SUNDRY NOTICES AND REPORTS ON WELLS

8. Well Name and No.
NDDUP UNIT 61

NDDUP Unit 61
30-015-26770
Yates Petroleum Corporation
October 31, 2013
Conditions of Approval

General Requirements for Plug Backs

WELL NAME: NDDUP #61 **FIELD:** Dagger Draw

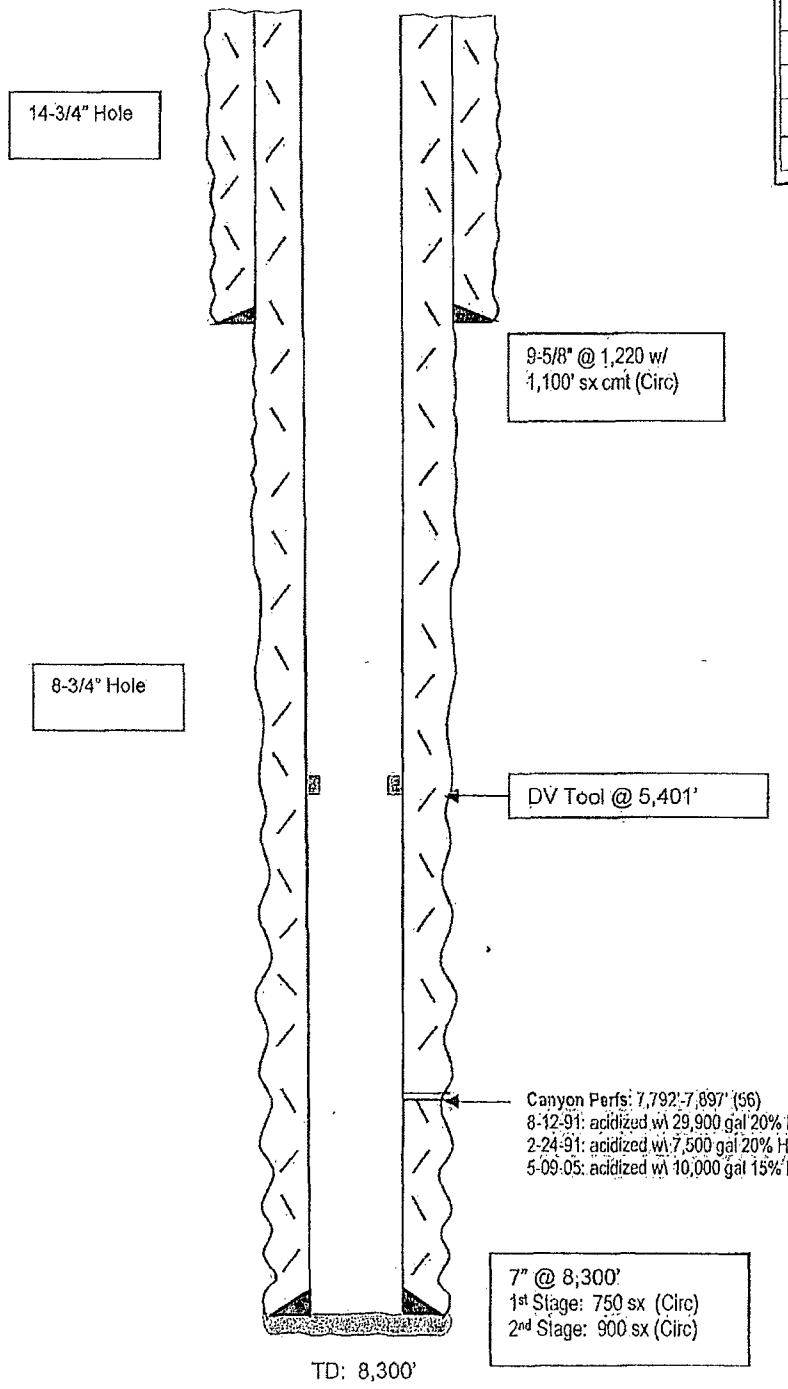
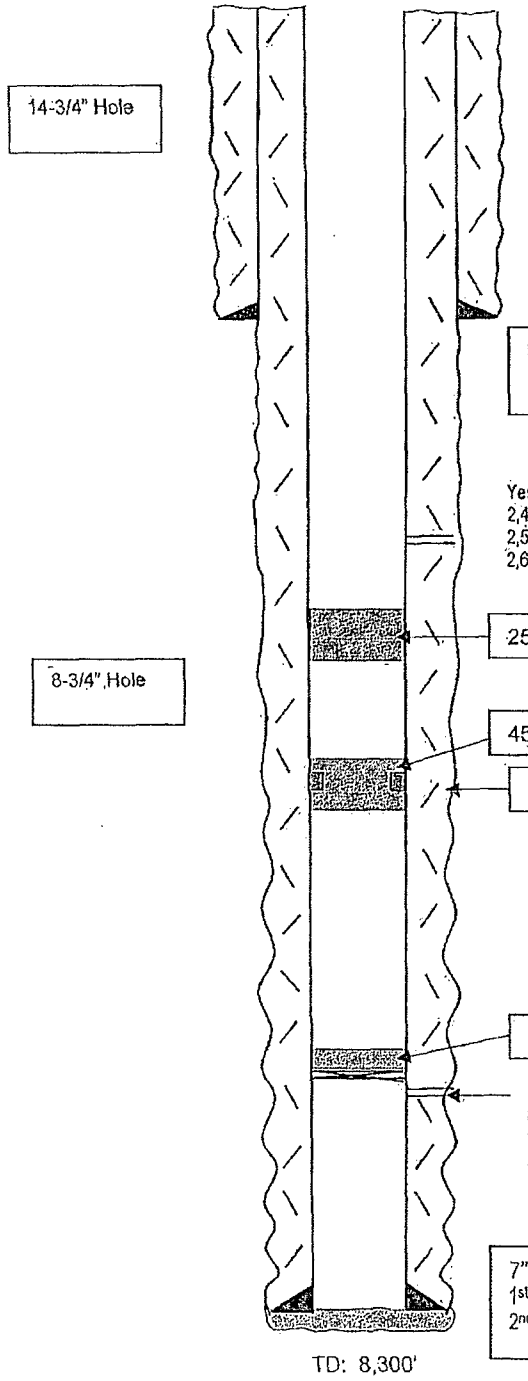
Yates Petroleum Corporation plans to plugback and recomplete this well as follows:
1. MIRU WSU and all safety equipment necessary. NU BOP. POOH with production equipment.

2. Run a gauge ring and junk basket to 7,750 ft. Set a CIBP at 7,742 ft and cap it with 25 sx of class H cement, this will place a plug over the open Canyon perforations.

3. Load the hole with plugging mud then spot a 45 sx class C plug from 5,301 ft-5,552 ft. Pull 5 stands and reverse circulate. This will leave a plug across the Wolfcamp top and the stage tool. WOC and tag; reset if necessary. Set a 25 sx class C plug from 3,497 ft-3,647 ft across the Bone Springs top. WOC and pressure test the casing to 3000 psi.

4. Perforate Yeso. 2,408 ft-2,612 ft (43 holes)
5. MIRU pump a fracture treatment at 100 BPM down the 7 inch casing limiting the surface treating pressure to 3000 psig. Set a pop off valve at 3500 psi. Over flush the bottom perforations by 600 bbls (treating schedule attached).

6. Flow the well back and allow the well to clean up. TIH with a bit to wash sand down to the PBTD.
7. TIH with 7 inch TAC and 2.875 inch tubing. Swab the well until it cleans up, then TIH with pumping equipment and turn the well over to the production department. Note: Name will change after well has been recompleted.
Schematics attached

1. **Operator to set CIBP at 7,742' and place 25 sx Class H Cement on top. Tag required.**

2. **Operator to set a balanced Class C Cement plug from 5,552'-5,301' to seal the top of the Wolfcamp formation. Tag required.**

3. **Operator to set a balanced Class C Cement plug from 3,647'-3,497' to seal the top of the Bone Spring formation.**

4. **Must conduct a casing integrity test before perforating and fracturing. Submit results to BLM. The CIT is to be performed on the production casing to max treating pressure. Notify BLM if test fails.**
